HISTORIC AND DESIGN REVIEW COMMISSION

HDRC CASE NO: 2021-493
ADDRESS: 419 N MESQUITE ST
423 N MESQUITE ST
427 N MESQUITE ST
LEGAL DESCRIPTION: NCB 568 (PROPERTIES AT MESQUITE (IDZ)), BLOCK 17 LOT 23
ZONING: RM-4, H
CITY COUNCIL DIST.: 2
DISTRICT: Dignowity Hill Historic District
APPLICANT: Peggy Brimhall/Figurd
OWNER: Monica Naves/Vergel Constrcutions
TYPE OF WORK: Construction of three, 2-story residential structures and one, detached 2-story accessory structure
APPLICATION RECEIVED: September 17, 2021
60-DAY REVIEW: Not applicable due to City Council Emergency Orders
CASE MANAGER: Edward Hall

The applicant is requesting a Certificate of Appropriateness for approval to construct three, 2-story, single-family residential structures and one, 2-story accessory structure on the vacant lots at 419, 423, and 427 N Mesquite. These lots are located within the Dignowity Hill Historic District.

5 NORTH ELEVATION - GARAGE
A2.00 SCALE 1/4" = 1'-0"

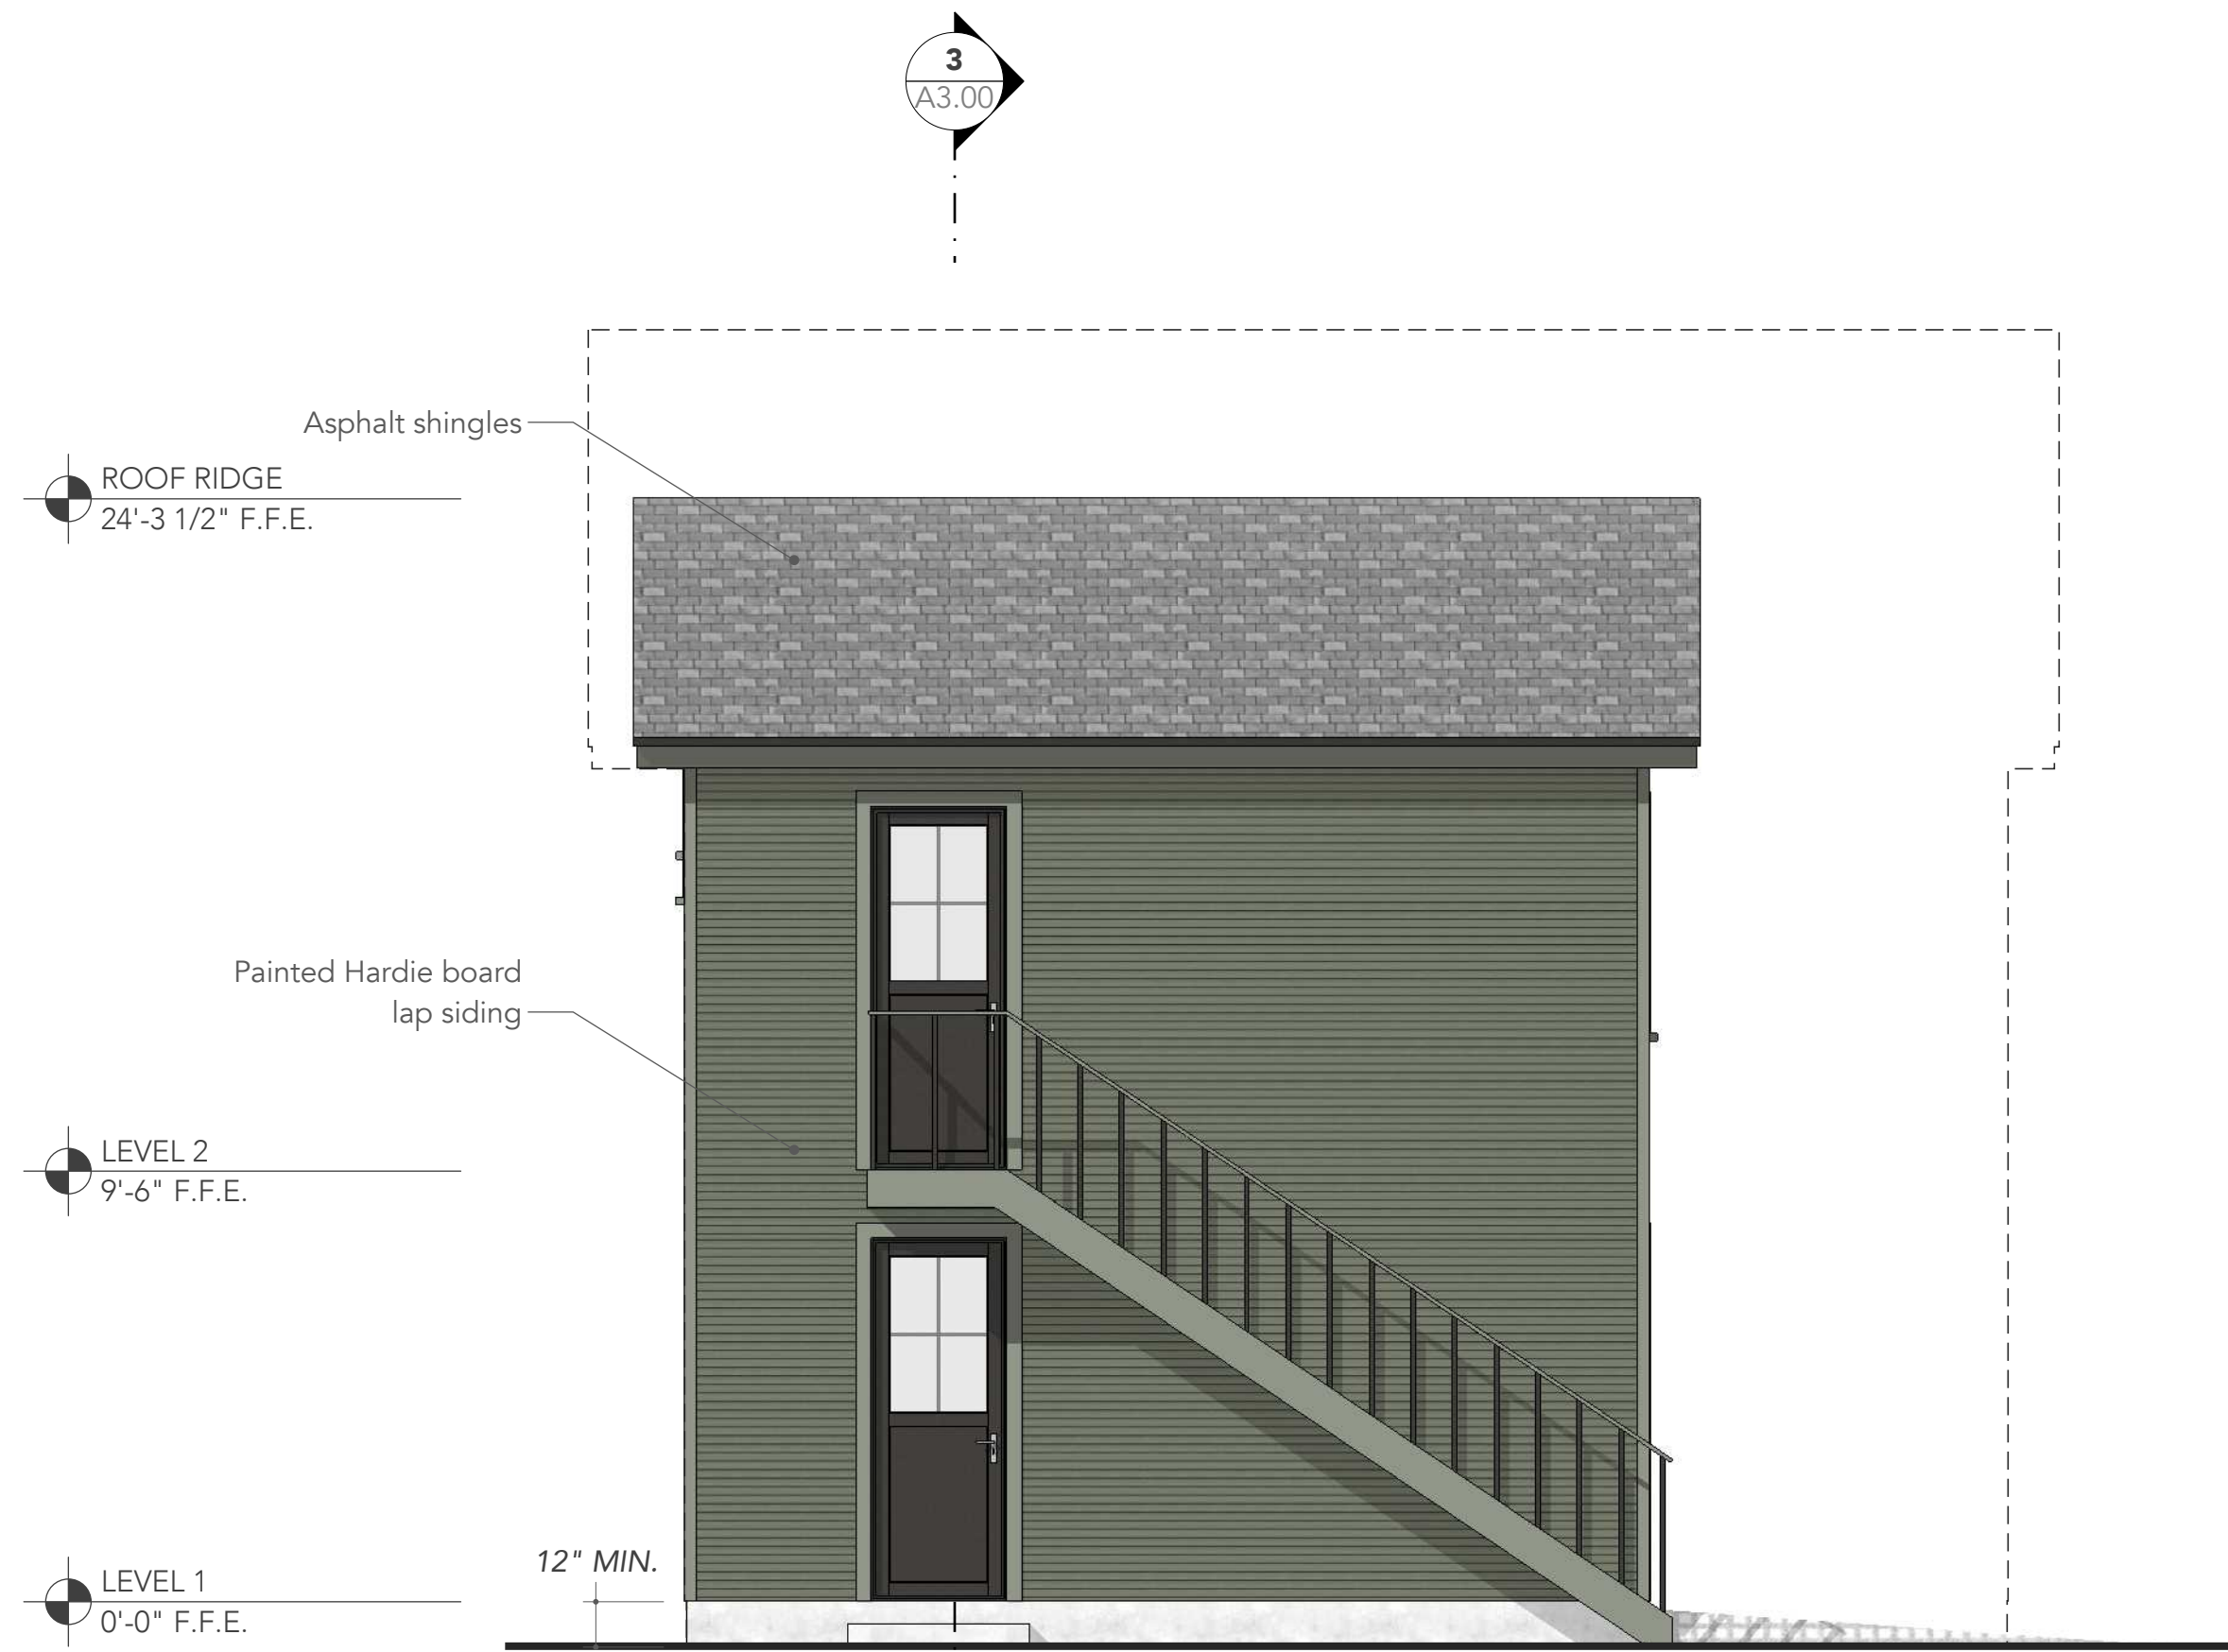
- r. ACCESSORY STRUCTURE – The applicant has proposed an accessory structure between buildings A and B to feature a footprint of approximately 235 square feet and two stories in height. The applicant has proposed for the accessory structure to feature a shed roof and a front facing garage door.

- s. ACCESSORY STRUCTURE – The Guidelines for New Construction note that accessory structure should be visually subordinate to the primary structure on the lot, should be no larger in plan than 40 percent of the primary structure, should relate to the period of construction of the primary structure on the lot, should feature similar window and door openings as those found historically and should feature garage doors similar in proportion to those found historically within the district. Additionally, the Guidelines note that the location of accessory structures on site should be consistent with those found historically within the district; towards the rear of the lot. Generally, staff finds the proposed accessory structure to be appropriate; however, staff finds that fenestration should be added and that fenestration should be consistent with that found historically within the district.

JF: Questions regarding the ceiling height of garage and main house? Intended to be. The garage appears out of scale – consider lowering the ceiling height of the second floor to 8 feet. PG: Top plate height could be 7 feet with open gable ceiling.

JF: Adding fenestration to blank wall façade would help.

- v. That all square, fixed windows are eliminated and replaced with larger windows that feature a one over one profile with operable sashes, including those found on the accessory structure, and that fenestration be added to the accessory structure's blank facades, as noted in finding s.
